**SUWANNEE RIVER WATER MANAGEMENT DISTRICT
UPPER AND MIDDLE SUWANNEE RIVER MFLS PEER REVIEW KICKOFF MEETING
MARCH 15, 2023**

Upper and Middle Suwannee River MFLs

Observations from Initial Review for Consideration by Peer Reviewers

March 15, 2023

Figure 2-29. Ellaville and Branford RTF adjustment factors

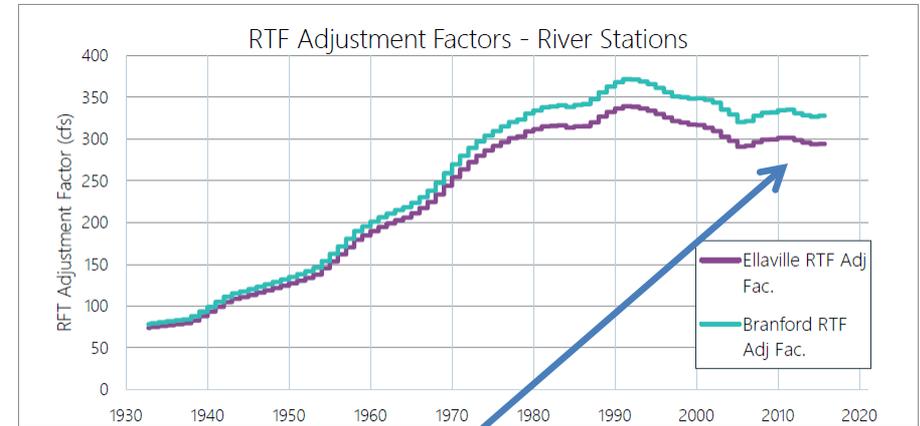
Reconcile Potential Inconsistencies Between RTF and NFSEG

- Adjustment factors show the impact of groundwater withdrawals and return flows
 - Based on several estimates and factors from NFSEG
- From adjustment method, MFL would be currently met
- Based on NFSEG, the MFL would be currently violated
- These should be consistent

Current adjustment:	MFL allowable change:
Ellaville ~295 cfs	Ellaville ~346 cfs
Branford ~360 cfs	Branford ~400 cfs

Change from NFSEG (Pumps off to Current):
Ellaville ~387 cfs
Branford ~432 cfs
